SERVICE BULLETIN

APPLICABILITY: 2013-14MY BRZ

NUMBER: 07-79-13R

SUBJECT: Countermeasures for Frozen Power Windows

Guide Door Lifter Service Procedure

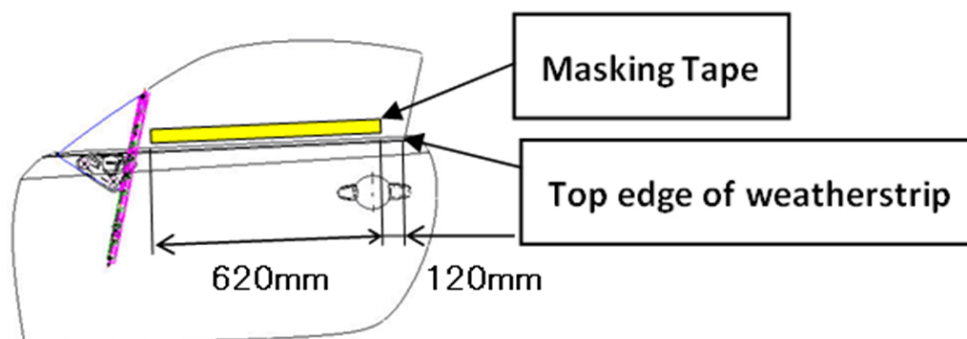
IMPORTANT: The guide door lifters **must** be replaced at the same time the countermeasure power window switches are installed. See the comparison illustration below.

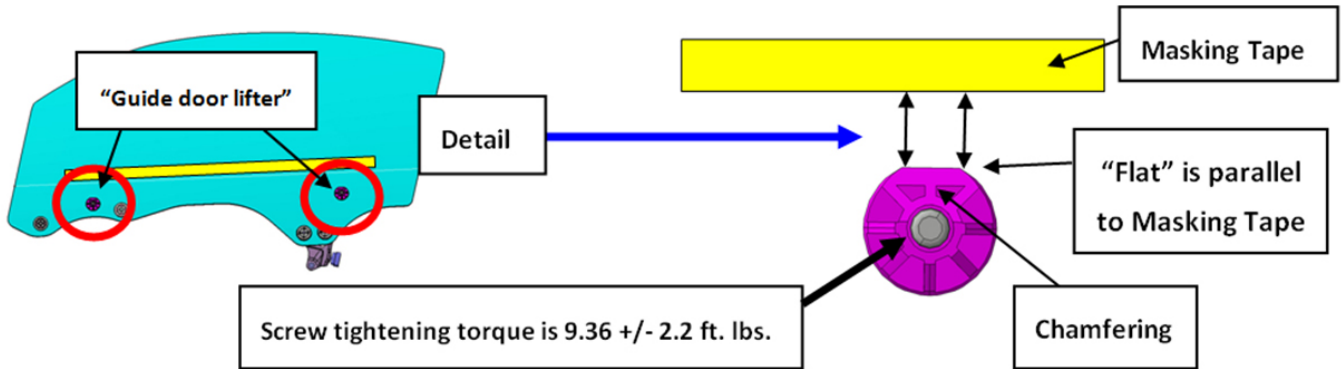
- With the door and the door glass fully closed, use masking tape to “mark” the position of the glass in relation to the outer weatherstrip top edge as shown in the illustration below.

- **Carefully** remove both door glass assemblies following the procedures outlined in the applicable Service Manual.
- Remove the old guide door lifters from the door glass assembly and replace with the new parts. The “flats” must be positioned at 12:00 and parallel to the bottom edge of the masking tape as shown in the illustration below. The retaining screws can be reused and get torqued to 9.36 +/- 2.2 ft. lbs. Should any of the screws be misplaced, the replacement part number is 904530039.
